EMBARK H&H HOMES

PLAN REVISIONS

Buyer Marked

EMBARK (GARAGE LEFT)
H&H HOMES

TITLE
ELECTRICAL PLAN

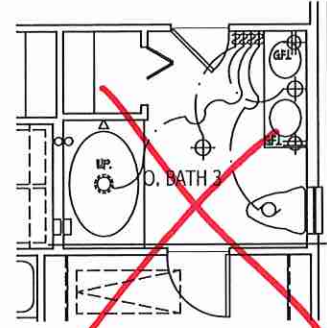
*see CPI PLAN

ELECTRICAL PLAN

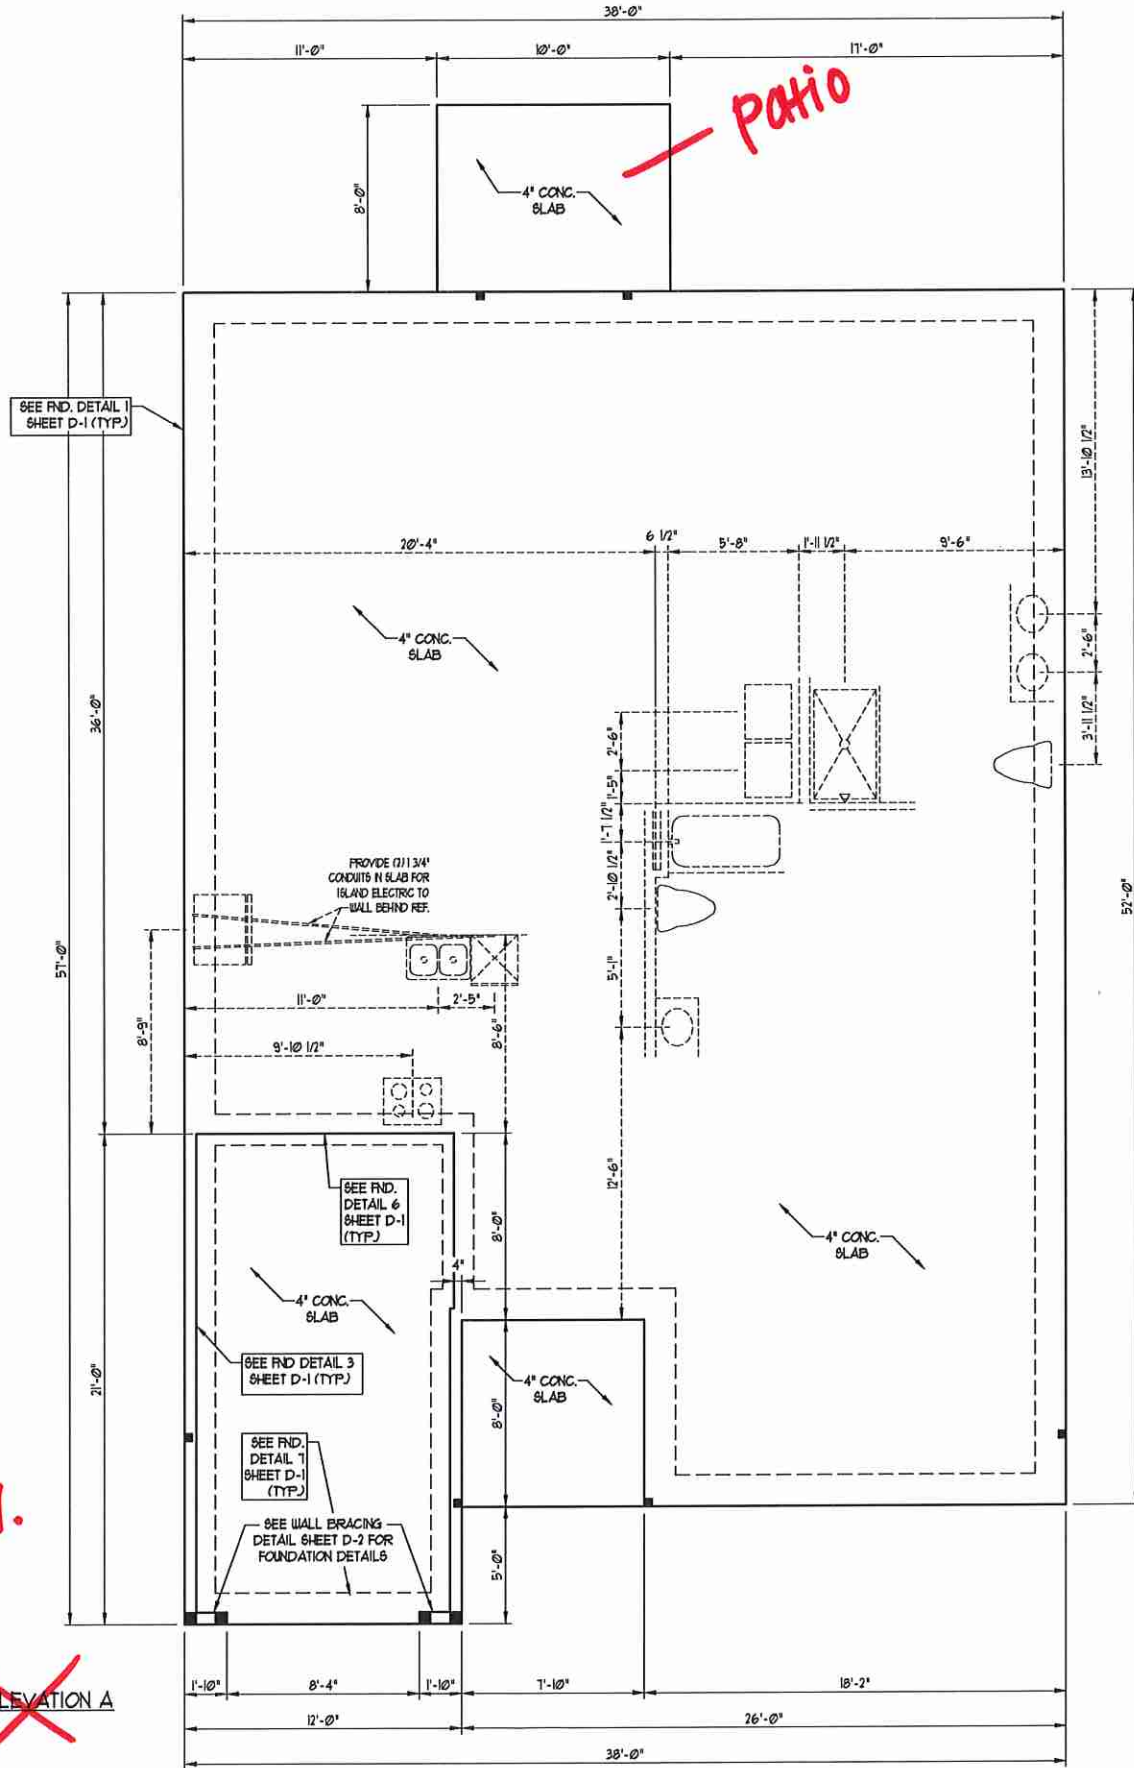
see elev.
B
~~ELEVATION A~~
